WINTER GARDEN
CITY OF WINTER GARDEN
DEVELOPMENT REVIEW COMMITTEE
MINUTES
JULY 2, 2025

Agenda Item #3.A: Johns Lake PD - UVPUD Rezoning

23. Sheet C2.50 Open Space Plan:

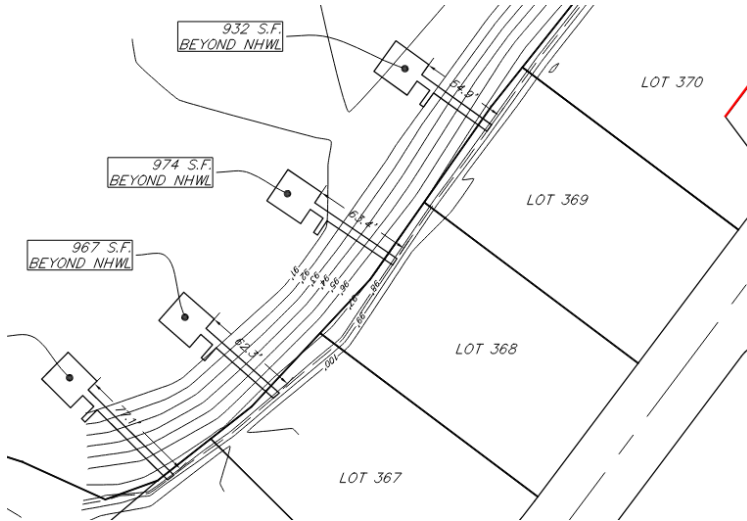
- b. What is being conveyed in the below Tract Table? How are the active recreation acreages larger than the tract acreages? As an example, there is a lift station tract (LS-1) listed as 0.06 acres. Besides that, is an active recreation acreage of 0.47 acres. Also, is the applicant using a lift station tract to satisfy active recreation? The applicants stated every number in the table below needed to slide up one and then the numbers would be correct. This will be updated in next submittal.

25. Public Realm Vision:

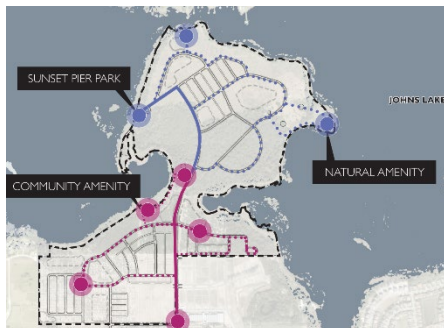
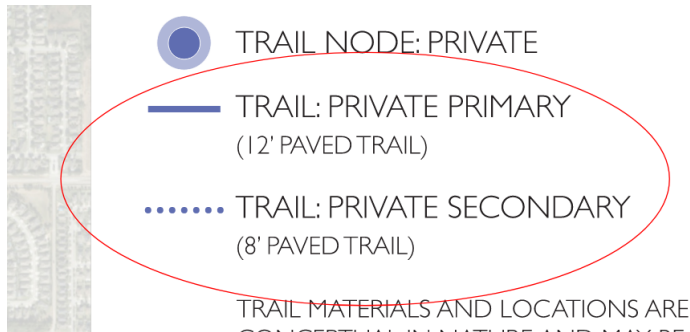
- b. Why is the sidewalk and trail system on Phase 2 labeled private (see images)?** Applicants requested clarification of this comment and a discussion ensued. City staff stated the sidewalk is privately maintained but would have public access; and applicants may want to consider using an unlocked gate with sidewalk access. Applicants will revise plan with next submittal.
